REQUEST FOR FURTHER INFORMATION - PRIVATE PLAN CHANGE 29 - SUMMERSET VILLAGES (RANGIORA) LIMITED, 141 SOUTH BELT, RANGIORA

Project Name.
SUMMERSET VILLAGE
RANGIORA

Drawing Title.
SOUTH BELT OUTLINE
DEVELOPMENT PLAN

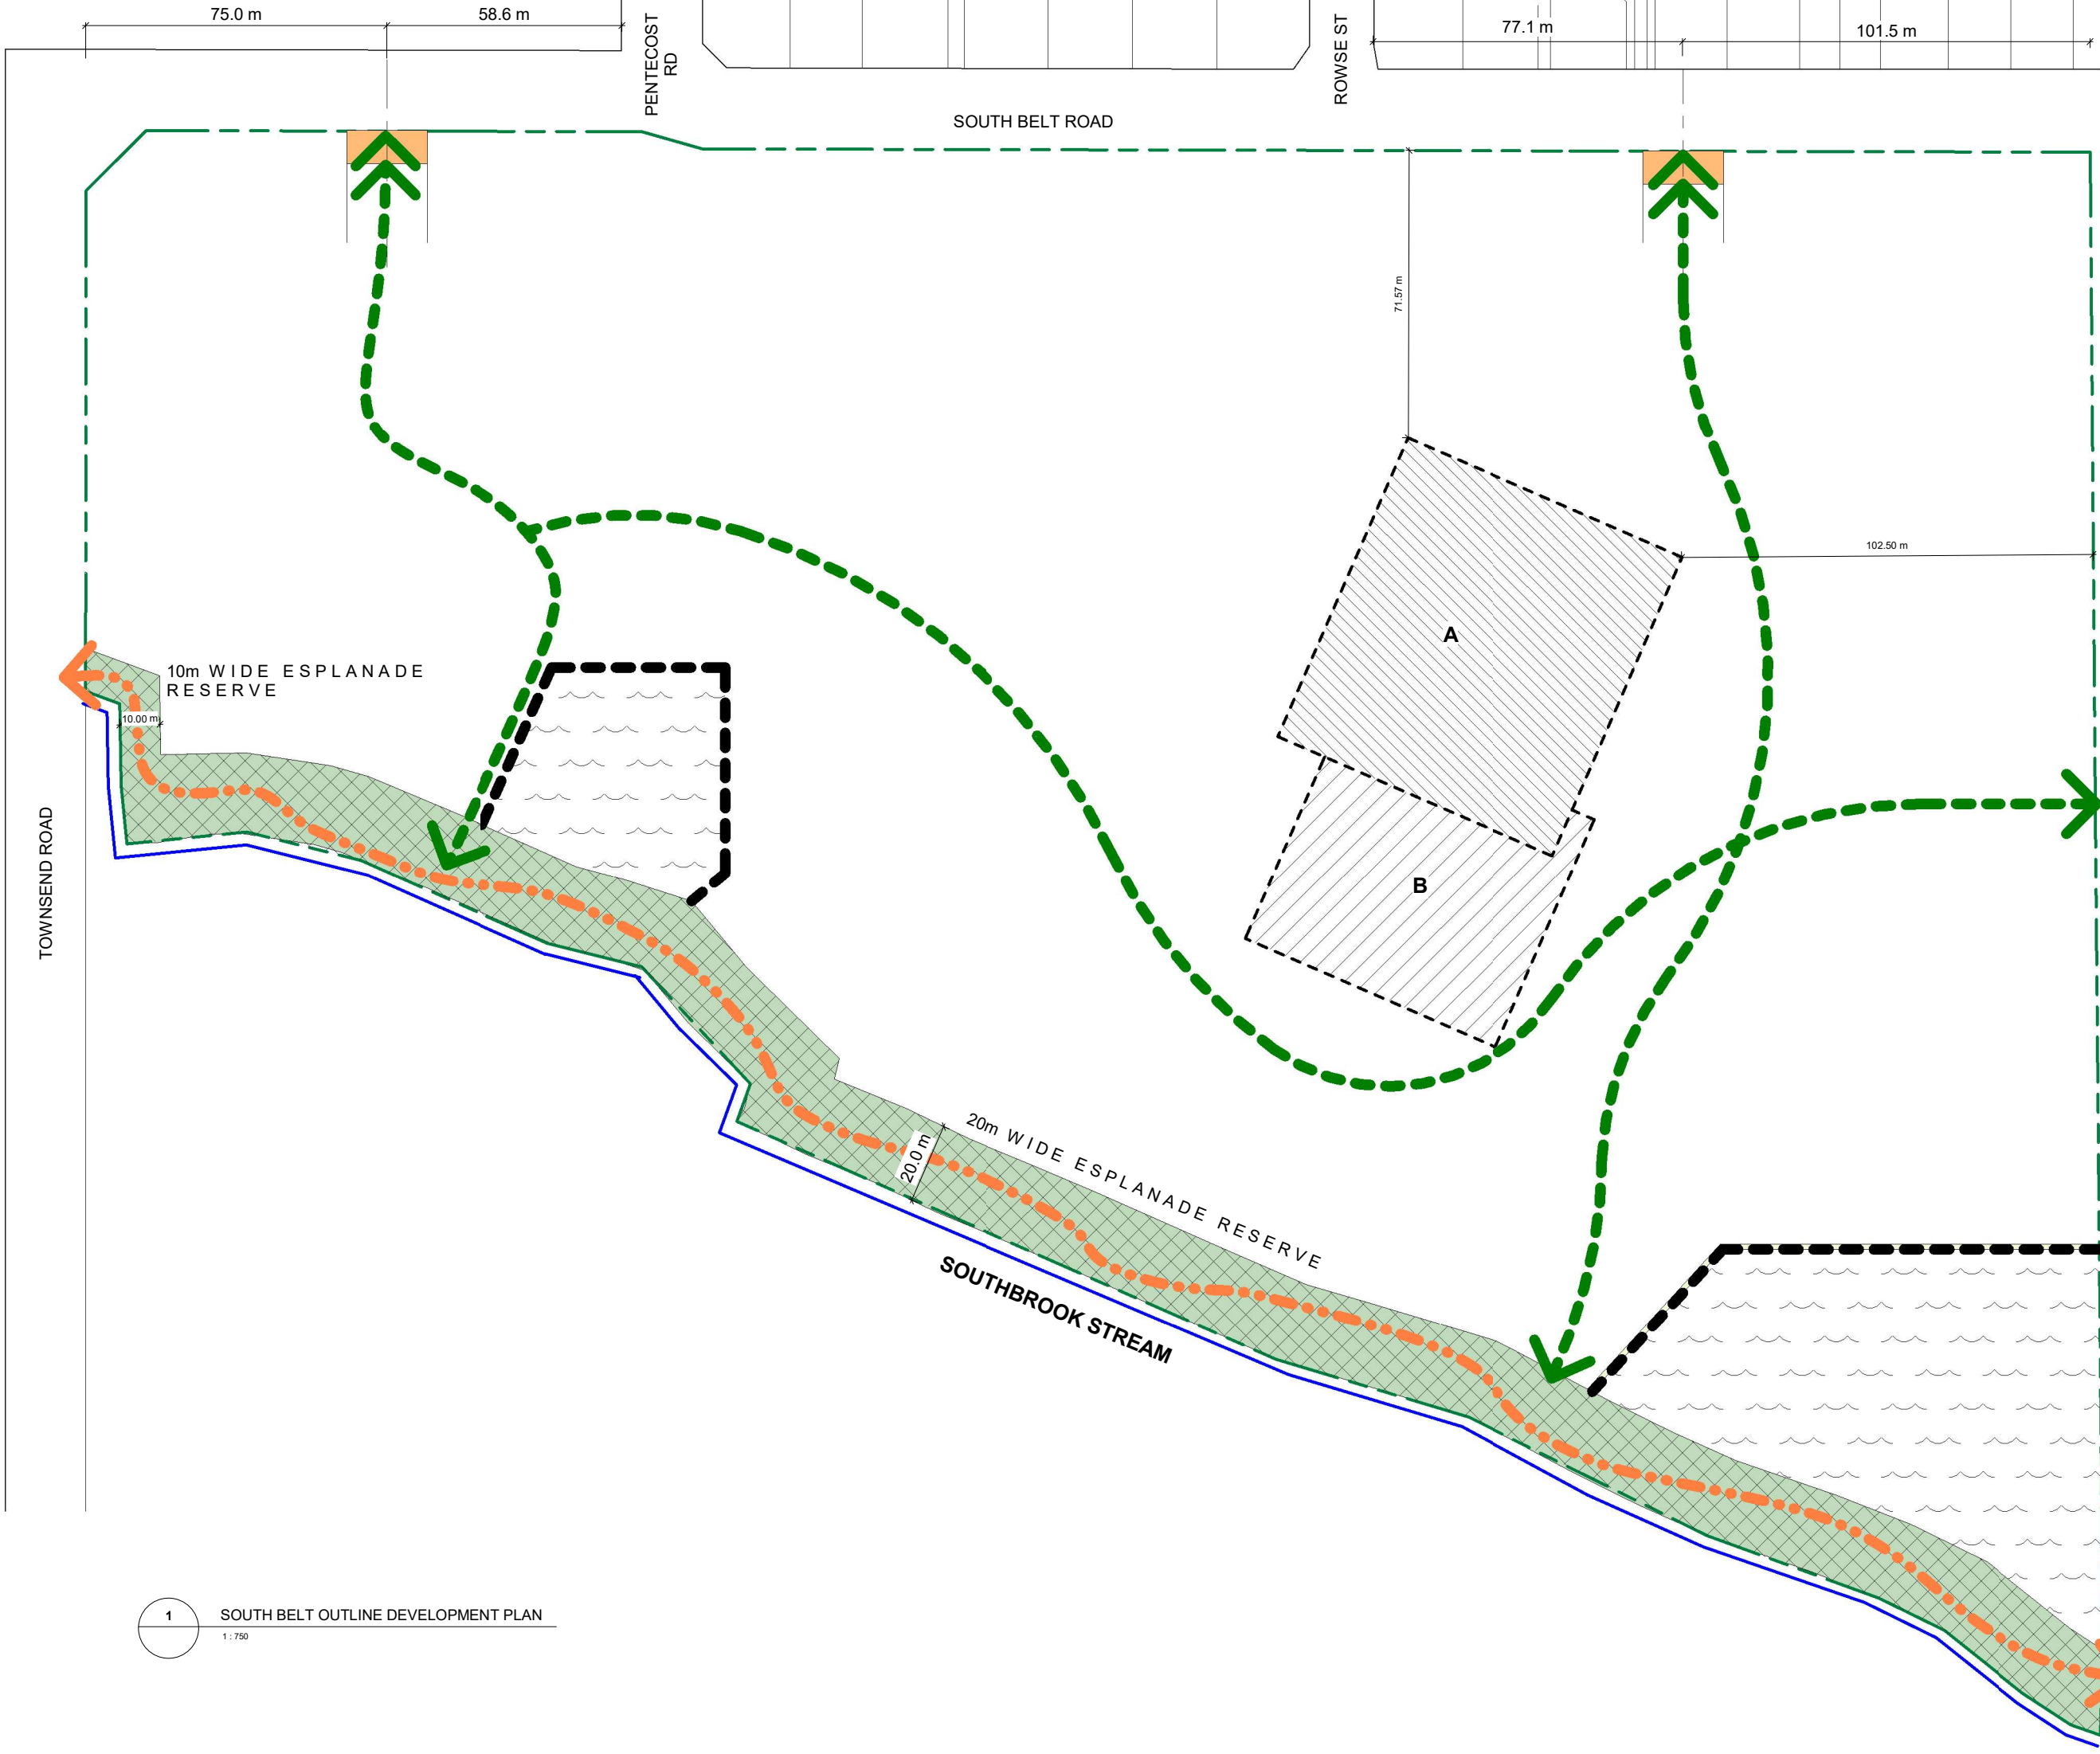
<p><i>It is noted that the esplanade narrows in width in the western portion of the ODP area however states 20m wide esplanade reserve. While the reason for this is understood, the plan change should consider the potential amenity and maintenance effects of the narrowing of the esplanade. The purpose of this is to ensure that the narrowed area will be of a sufficient width to accommodate a walkway/cycleway, any proposed enhancement, and to allow access for maintenance equipment. One way to achieve this may be a cross-section of the esplanade reserve at this location.</i></p>	<p>Through discussions with the Council's parks manager prior to lodging the plan change it was agreed that 10m is an appropriate width for the esplanade reserve at the western end of the site based on the width of the stream, the bridge location and the location and width of the esplanade on the western side of Townsend Road. The ODP has been amended to show this small area with a narrower width.</p> <p>The recently granted subdivision of the site, the ODP and any future subdivision or use of the site will require vesting of the esplanade reserve with the Council. Once the land has been vested in Council, the appropriate design will be undertaken by Council staff to ensure that the use of this reserve land is appropriate. It is not possible for us to speculate on what walkway/cycleway widths, enhancement, etc the Council may want to achieve within this space and on what will be Council land. We understand from pre-application discussions with Council that they are comfortable that their intended use will fit into this space.</p>

<p><i>Please clarify why a setback rule for Area A and Area B has not been included within the proposed Plan Change?</i></p>	<p>The proposed Height Areas A and B identified on the ODP are intended to provide for a specific part of the site where taller buildings can be established within the site to facilitate a retirement village development. The effects of this additional building height have been assessed as part of the plan change.</p> <p>The area in which this additional height would be located is fixed by the ODP and this defines the setback of this area from the boundaries of the site, thus ensuring that it is internalised within the site. These areas are deliberately located away from site/zone boundaries to internalize potential adverse effects.</p> <p>It is not considered necessary to provide a setback within each height area, given that the site and buildings within it can be designed to minimize effects on residents in the retirement village.</p>

- 33.1.7 Esplanade reserves shall be provided for land adjoining the Southbrook Stream as shown on the South Belt Outline Development Plan. The esplanade reserves shall conform with the dimensions shown on South Belt Outline Development Plan as shown on District Plan Map 184.
